Southern Nuclear Operating Company
Vogtle Early Site Permit Application
Safety Review Site Audit Meteorology Information Needs

1. Responses to NRC Site Meteorology Information Needs from December 2006 Safety Review Site Audit for Vogtle ESP Application
2. Response Attachments

Information Needs from the December 2006 Safety Review Site Audit

Figure 2.3-1 Climatological Observing Stations Near the VEGP Site

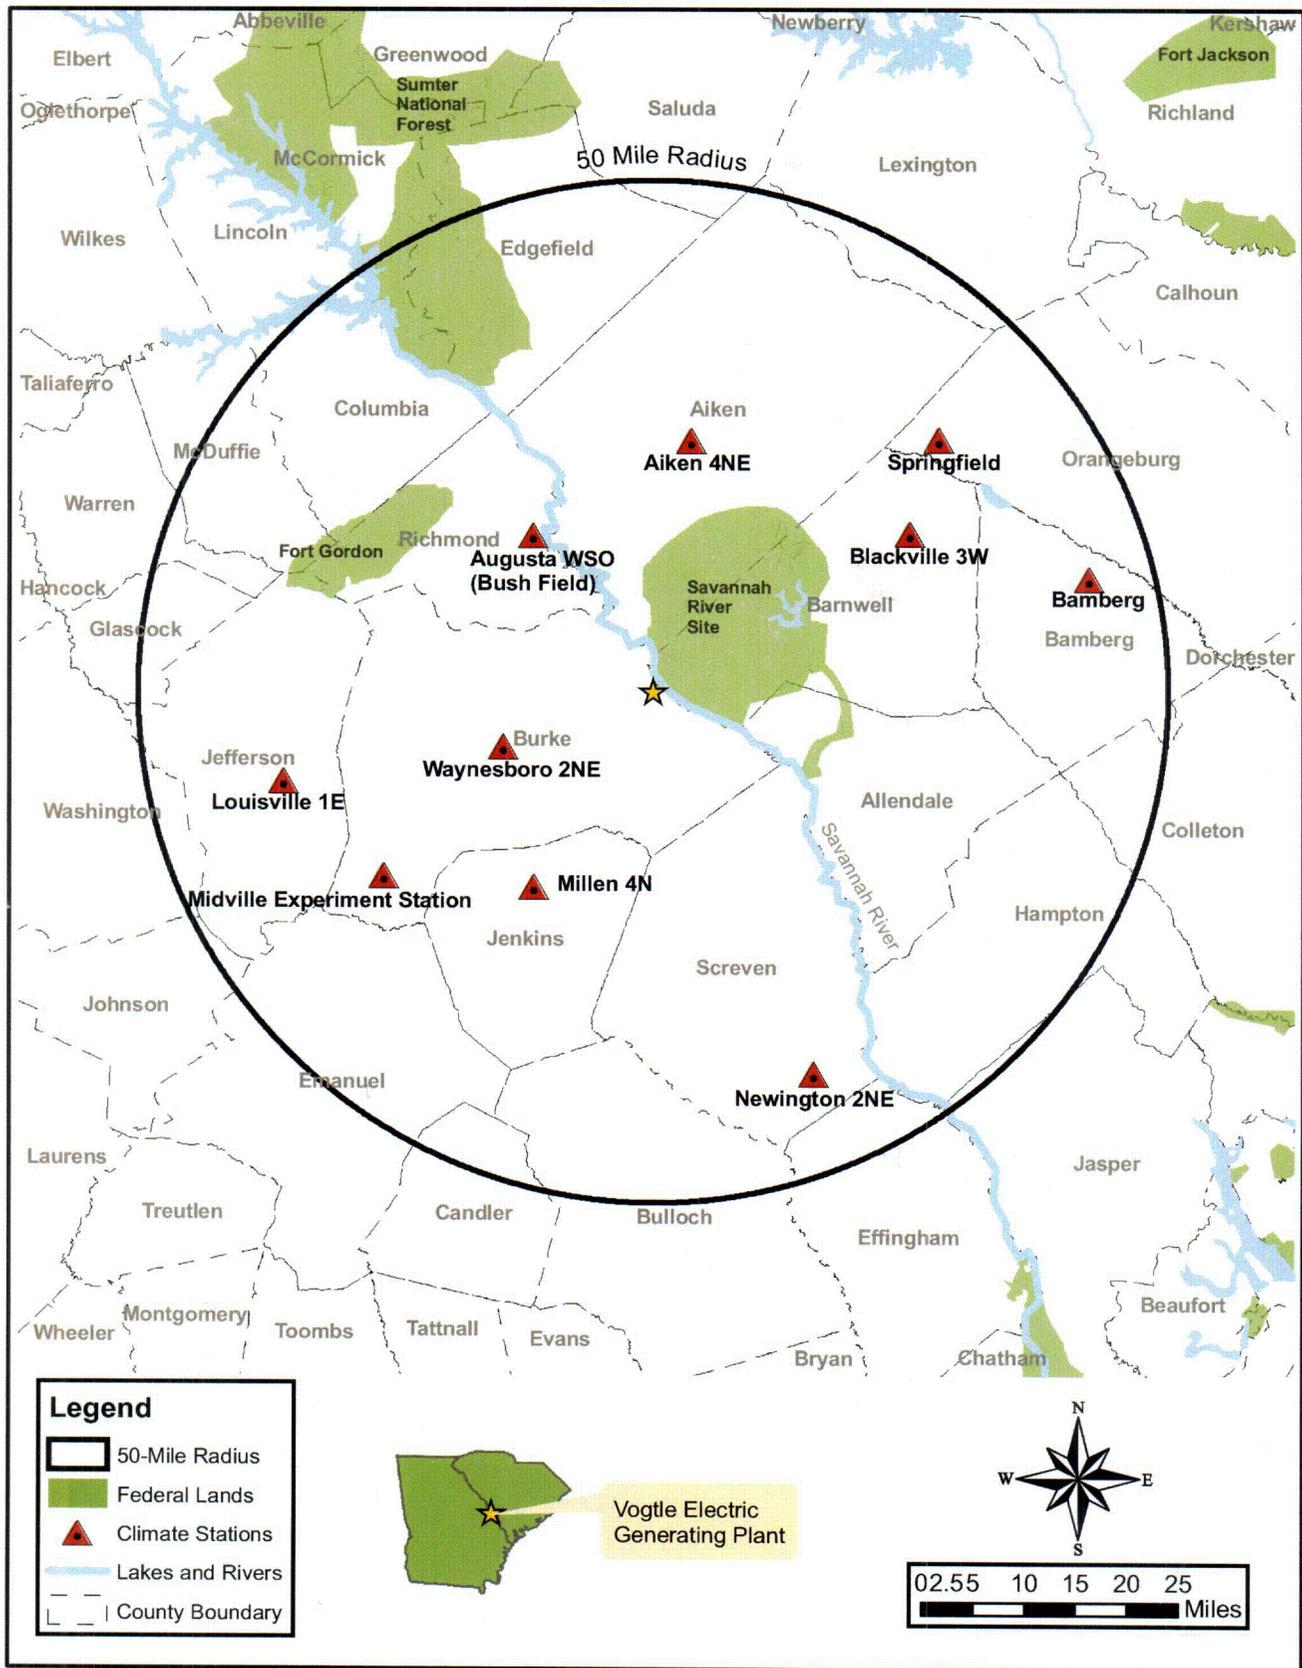
2.3.1-2 Eight climatological observing stations were used to characterize the regional climatology of the Vogtle ESP site. The staff identified a total of seventeen observing stations around (i.e. within a 50 mile radius) the Vogtle ESP site with 13 to 94 years of available data. Please explain the selection process used for the eight observation stations listed in the SSAR.

2.3.1-3 Using the eight observing stations identified in SSAR Section 2.3.1.1, regional climatological precipitation statistics of the site are presented in SSAR Section 2.3.1.3.4, "Precipitation Extremes" and summarized in Table 2.3.3, "Climatological Extremes at Selected NWS and Cooperative Observing Stations in the VEGP Site Area." Using climatic data from NCDC, the staff found a higher maximum monthly rainfall observation at Louisville, GA and a higher maximum 24-hr snowfall and maximum monthly snowfall observation at Bamberg, SC as compared to the values in SSAR Table 2.3.3. Please confirm that the values presented are the most extreme values for the proposed Vogtle ESP site.

2.3.2-5 SSAR Section 2.3.2.2.3 states that “extreme maximum temperatures recorded in the vicinity of the VEGP site have ranged from 105oF to 110oF, with the highest reading observed at the Newington 2NE Station on July 13th, 1980.” However, the staff found a higher extreme maximum temperature recorded in the vicinity of the VEGP site, 112oF, which occurred at Louisville 1E on July 24th, 1952.

The 50-mile radius circle shown in Figure 2.3-1 is only used to provide the reader with a relative indication of the distance between the climate observing stations and the VEGP site. A 50-km (about 31-mile) grid spacing is considered to be a reasonably fine mesh grid in current regional climate modeling and this distance was used as a nominal radius for the station selection process.

Also, upon further evaluation of the Bamberg Station record, this station will be added to Table 2.3-3 and Figure 2.3-1, despite its distance from the VEGP site (i.e., about 43.5 miles, or 70 km), because it contributes both the highest of the maximum daily and maximum monthly snowfall totals in the site area.

In evaluating the Louisville 1E station temperature records, SNC agrees with the reported overall maximum temperature value of 112°F. This station will be added to Table 2.3-3 and Figure 2.3-1 because it contributes the highest of the maximum daily temperature records in the site area despite its distance from the VEGP site (i.e., about 37 miles or 60 kilometers) exceeding the selection criteria discussed in response to Question 2.3.1-2.
